SERVICE BULLETIN - FUEL PUMP KIT (RH3397P)

This information can be found in SY/K19 of TSD4318 dated from 10/6/1985

PIERBURG FUEL PUMP

Fig. 1 Displaced fuel pump

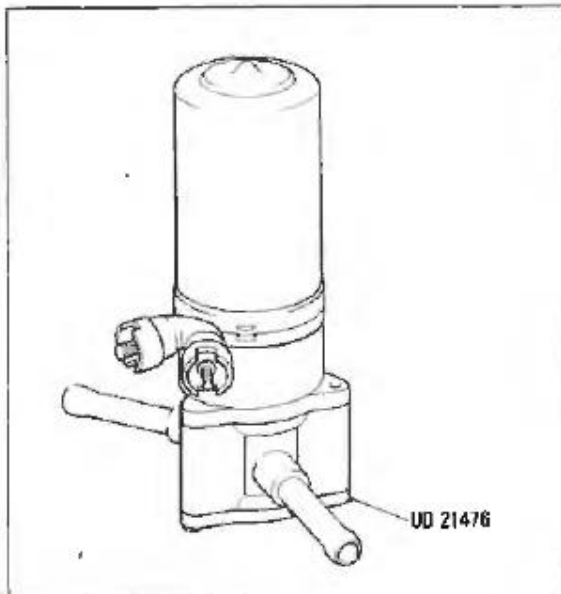
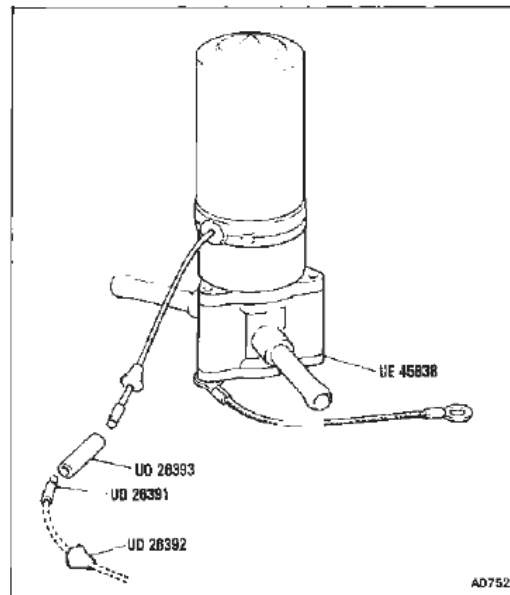
The new pump incorporates a different type of electrical connection. When used as a service replacement for the previous pump, a new type of Lucar connector will be required to adapt the existing wiring loom (see fig. 1 and 2).
